AMENDMENTS TO DA APPROVED STUDIO

17 Old Sydney Road, Seaforth

CALCULATIONS
REMAIN AS PER
APPROVED DA
NO: DA2021/1835

FLOOR PLAN

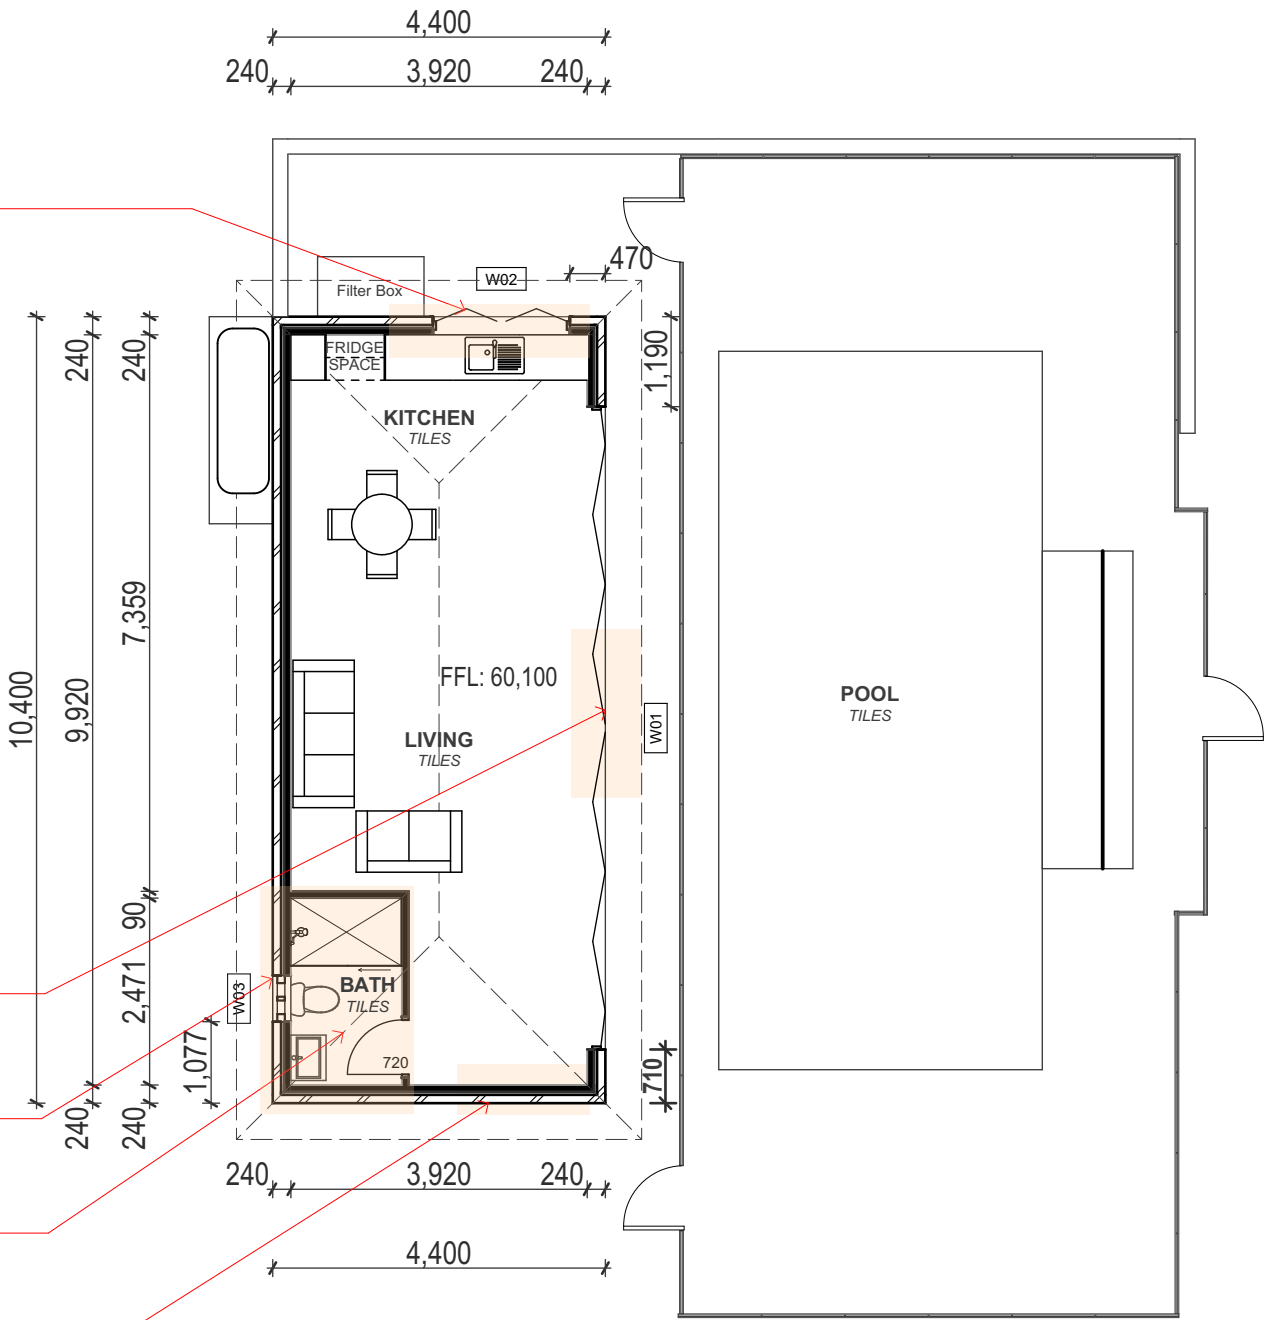
BIFOLD WINDOW MOVED TOWARDS FB
WIDTH CHANGED FROM
1370 mm TO 1810 mm (H 1029)

BATHROOM WINDOW MOVED
TO THE MIDDLE

BATHROOM LAYOUT
CHANGED

DOOR REMOVED
